PLANNING COMMISSION
EDWARDSVILLE, KANSAS

3. New Business:
   a. **Preliminary Plan and Special Use Permit (Continued discussion from September 21, 2016 Meeting)**– 201 N. 4th Street (2016-09 PPN / 2016-10 SUP) -Lois D. Roberts, Owner / Selective Site Consultants - Applicant

City of Edwardsville
Staff Analysis Report
Planning Commission October 19, 2016

Item 3a – (Continued Discussion from September 21, 2016 Meeting) Concept Plan / Special Use Permit (2016-09-PPN / 2016-10-SUP)

PDP-2

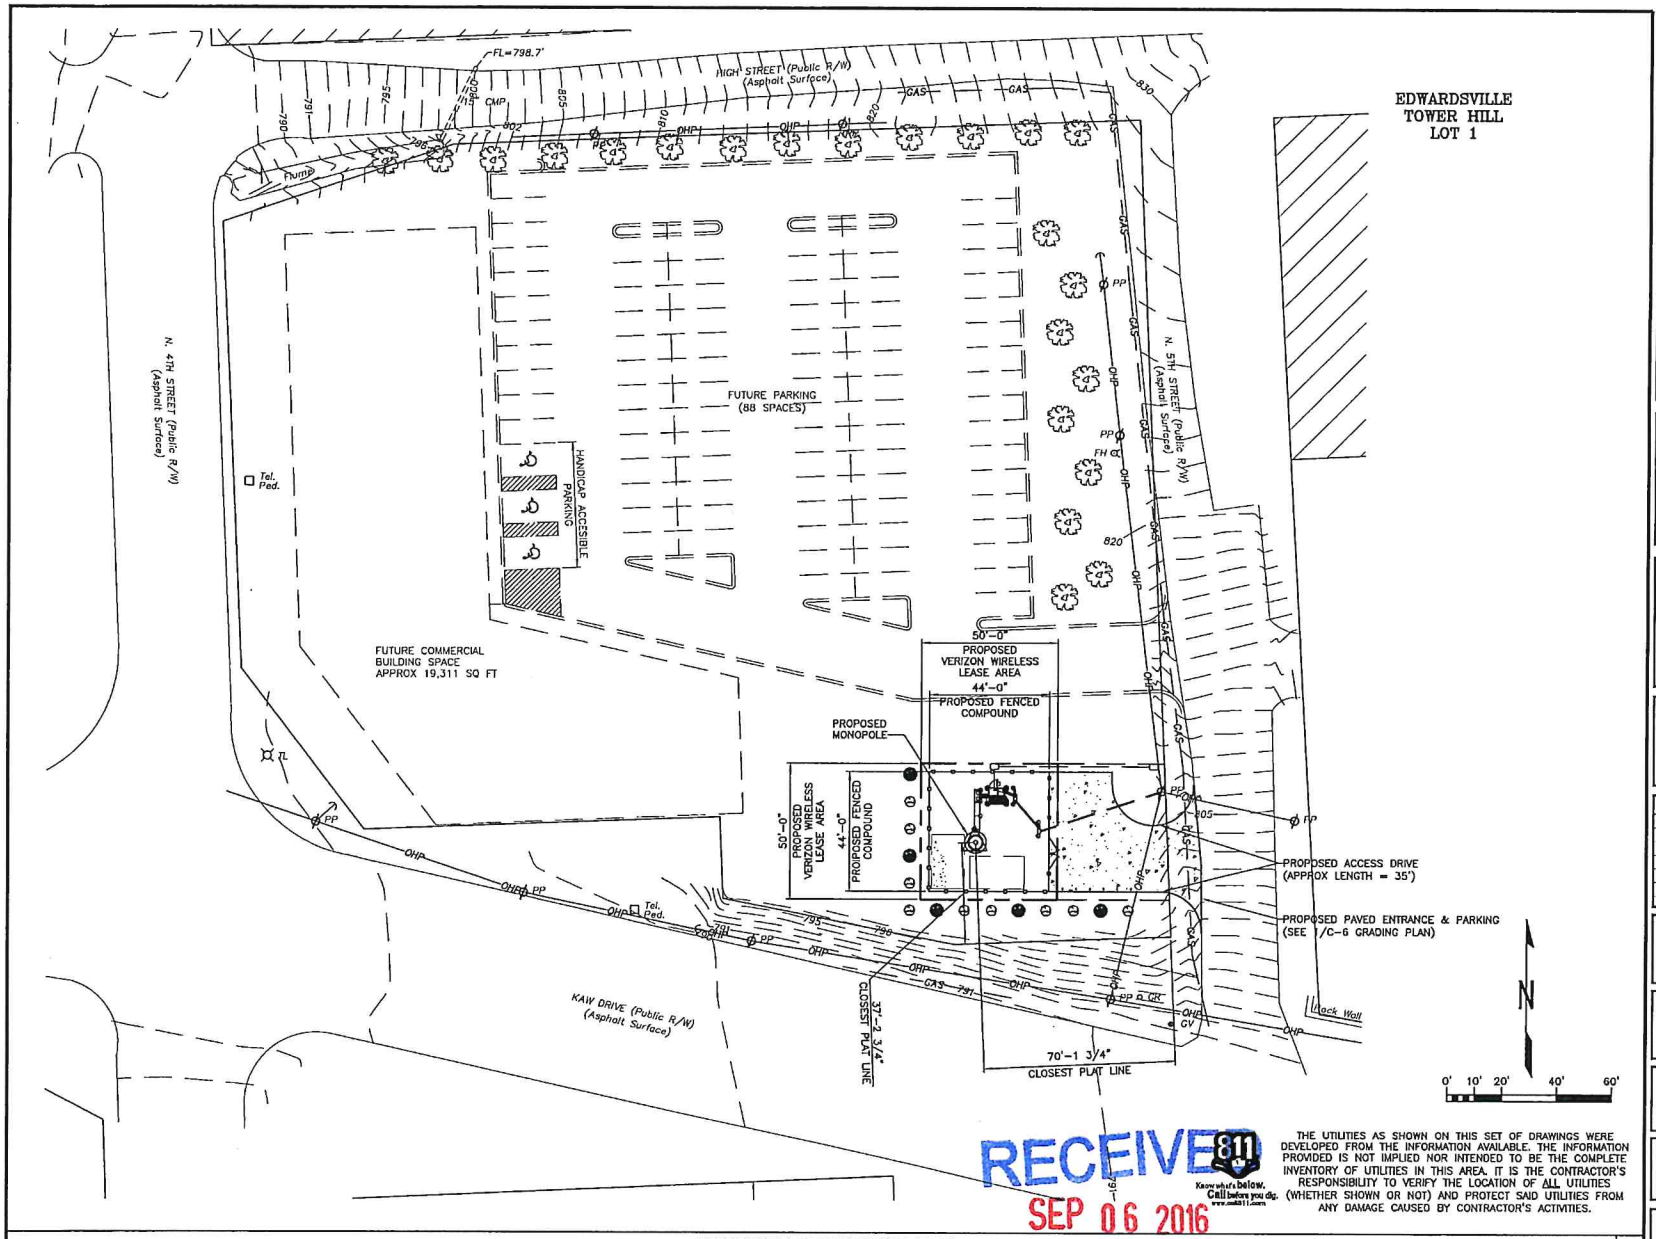
1. Adjust all plan documents to reflect up to date plat information per the recent replat of the property.
2. Move the proposed access drive to the tower as shown on 5th Street to the location identified as future access that is aligned with the existing drive on the east side of 5th Street on the conceptual development plan. This entry should be built as part of the proposed tower area to the west until it meets with the western edge (extended) of the paved area east of the proposed fenced area depicted on the submitted plan. The paved area adjacent to the tower fence (east side) should be extended to the entry drive to the north.

3. With revisions noted in item 2 above provide enhanced landscape screening east of the access / parking area.
4. The pad area associated with the fenced in area shall be a paved surface equivalent to the drive access and service parking area surfacing.

1. Adjust all plan documents to reflect up to date plat information per the recent replat of the property.
2. Move the proposed access drive to the tower as shown on 5th Street to the location identified as future access that is aligned with the existing drive on the east side of 5th Street on the conceptual development plan. This entry should be built as part of the proposed tower area to the west until it meets with the western edge (extended) of the paved area east of the proposed fenced area depicted on the submitted plan. The paved area adjacent to the tower fence (east side) should be extended to the entry drive to the north.

3. With revisions noted in item 2 above provide enhanced landscape screening east of the access / parking area.
4. The pad area associated with the fenced in area shall be a paved surface equivalent to the drive access and service parking area surfacing.
